***Item 11-1:  
Final Plans for Phase IV of the  
Lower Codornices Creek Restoration  
Project***

**CITY COUNCIL MEETING**  
October 21, 2019

**From:** [Ian MacLeod](#)  
**To:** [citycouncil](#)  
**Subject:** Codornices Creek Path Plan Item 11-1  
**Date:** Sunday, October 20, 2019 11:39:19 PM  
**Attachments:** [Codornices Plan L-4.1 10 20 2019.pdf](#)  
[Codornices Plan L-4.2 10 20 2019.pdf](#)  
[Codornices Plan L-4.3 10 20 2019.pdf](#)

**DESIGNED BY:** RAS, BS, MT  
**CHECKED BY:** ES, MT  
**SCALE:** 1" = 10'-0"  
**DATE:** OCTOBER 11, 2019  
**SHEET:** L-4.1  
 OF 19

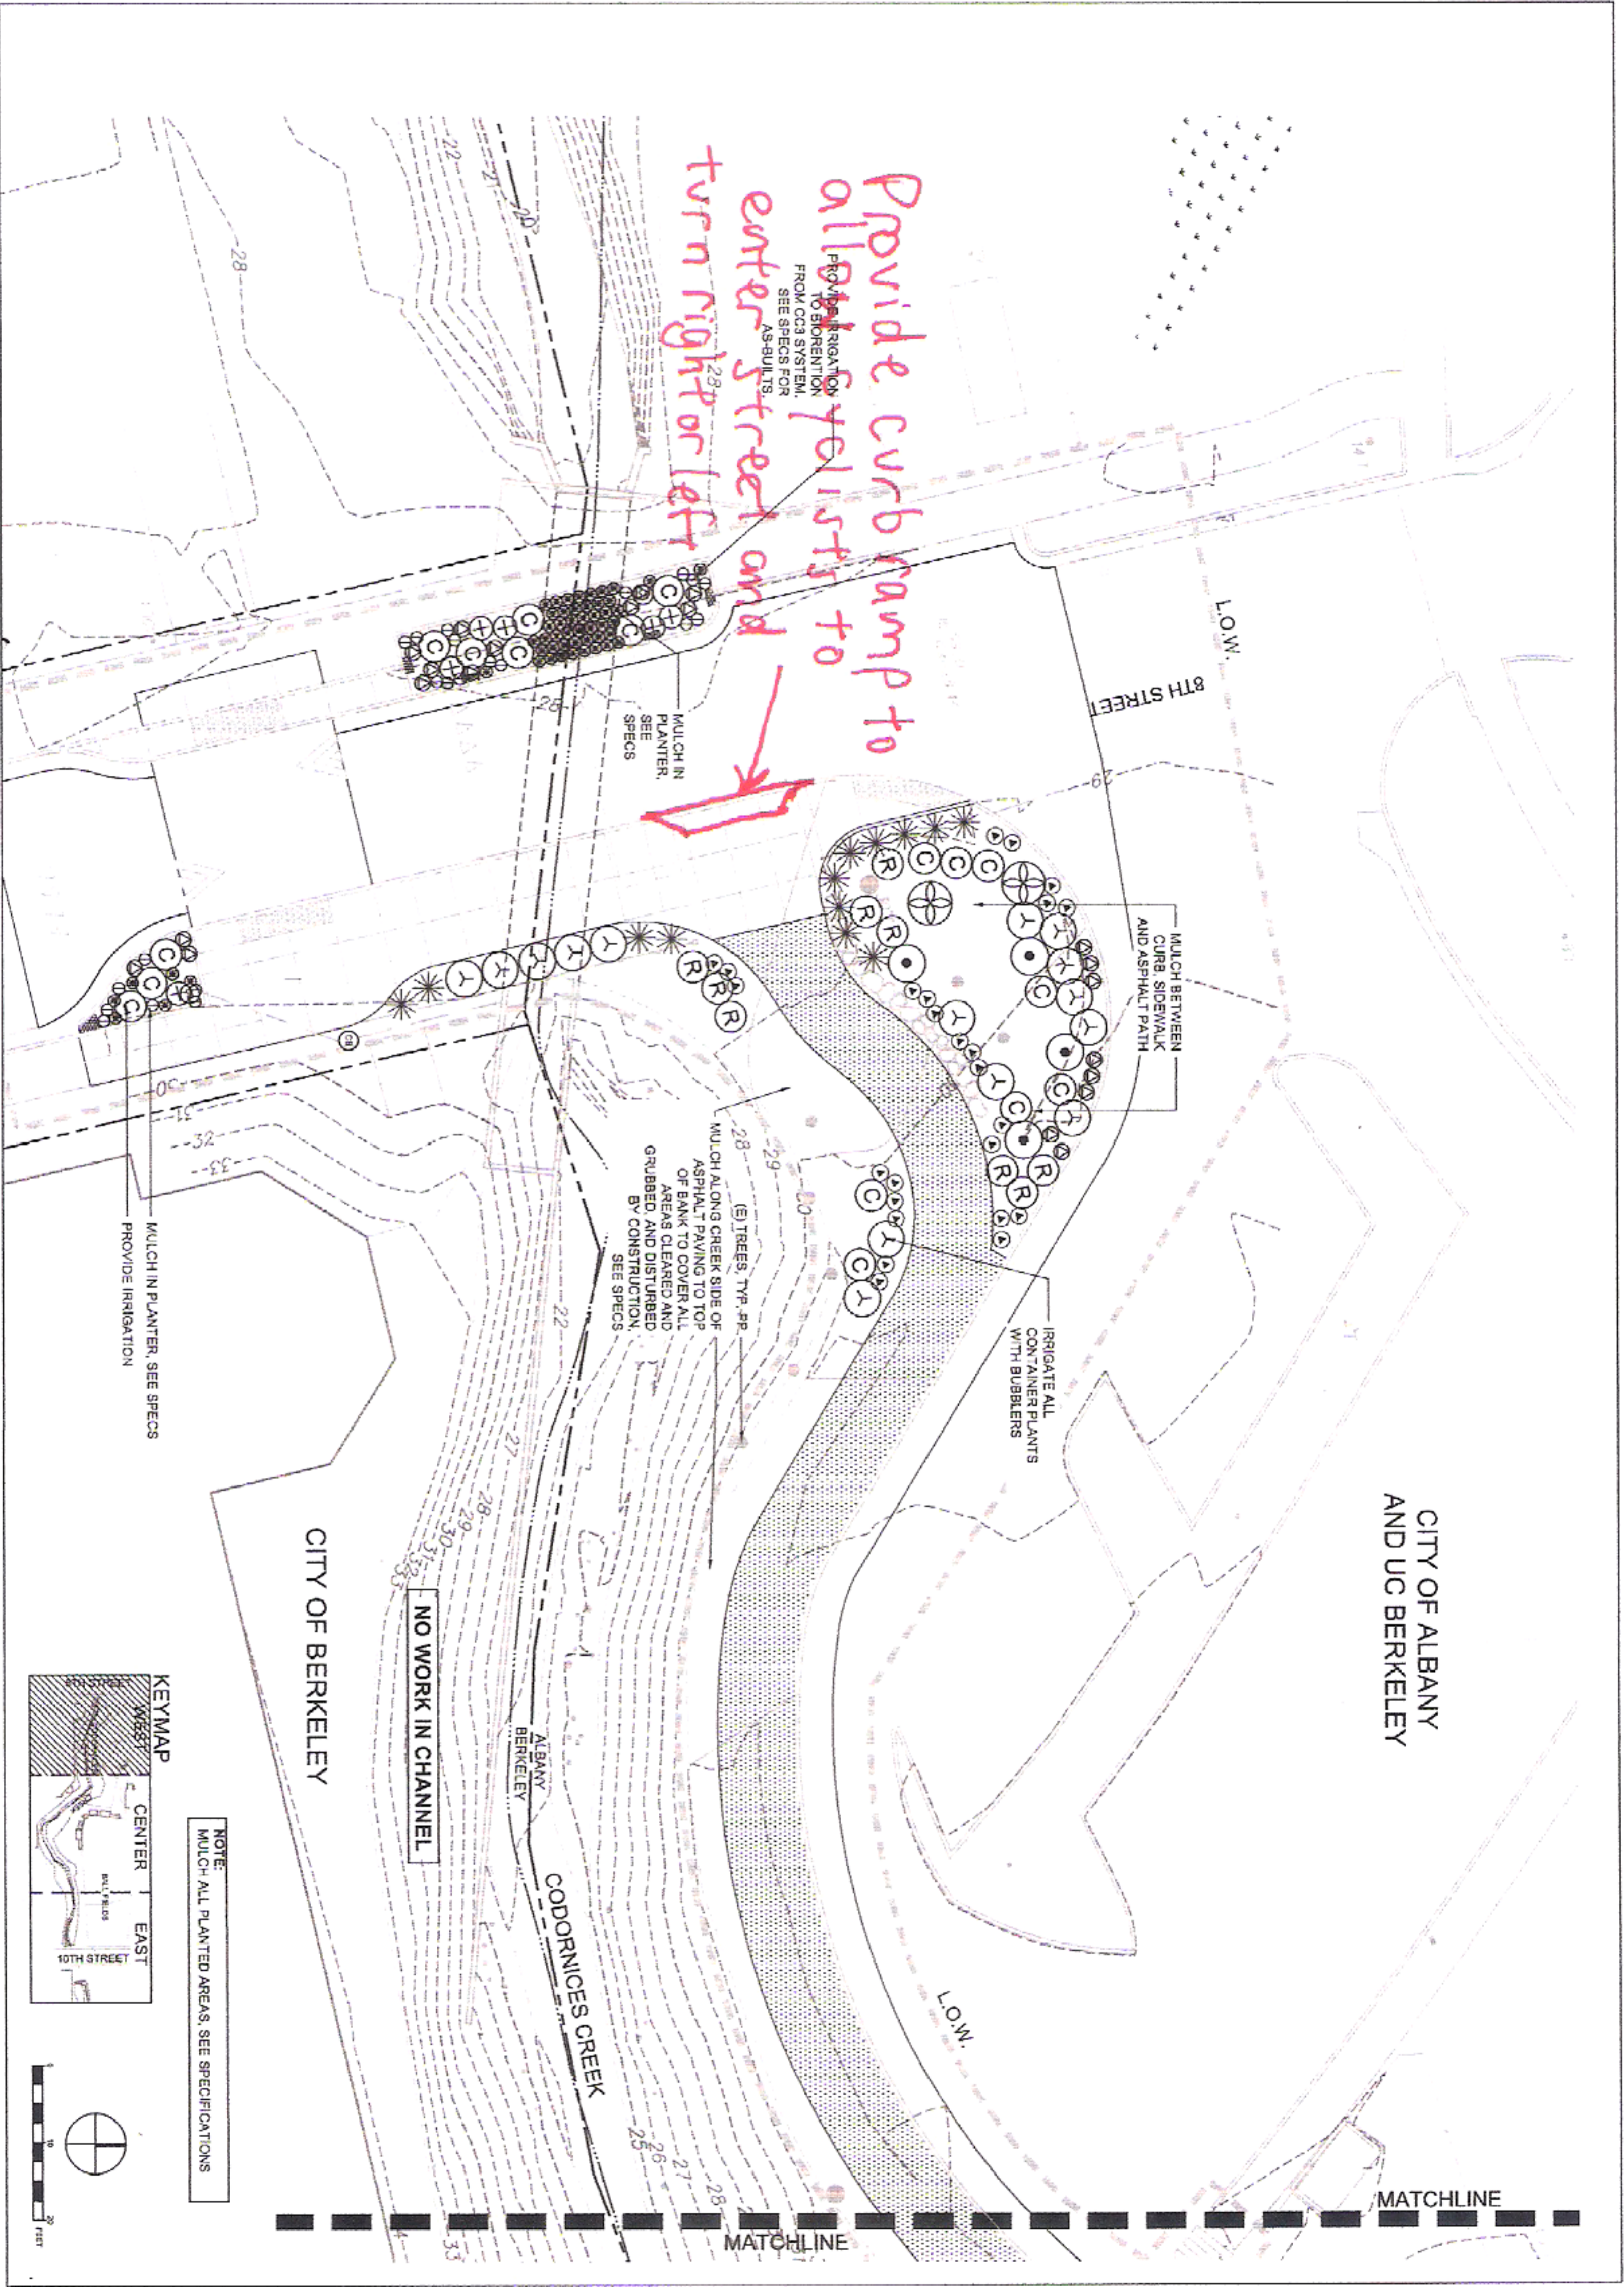
3. The end of the path at 8th St. It would be better to add a curb cut straight in line with the path to allow cyclists to enter the street directly and turn right or left on 8th. As a cyclist, I do not want to be forced to ride on the sidewalk with pedestrians. A curb cut in this location is a relatively inexpensive solution that allows for greater flexibility in for cyclists in this transition zone.

5. The landscape plan. Many of the plants are put too close to the path and will grow into the path and make it harder for pedestrians and cyclists to share the path. The plans on L-4.2 and L-4.3 show the low fence moved south away a couple of feet from the path as requested, but now that strip is filled in with big boxy bushes, which totally defeats the purpose of moving the fence. The plants should be removed and the ground left flat as a buffer zone in front of the fence. In general, however, I wonder about the wisdom of doing any planting at all with irrigation, planters, and boulders, etc. A better solution would be to coordinate the work with full creek restoration, non-native plant removal, along with allowing selected native species to reestablish themselves as has been done elsewhere on Codornices Creek. The creek should be allowed to return to its natural state as much as possible.
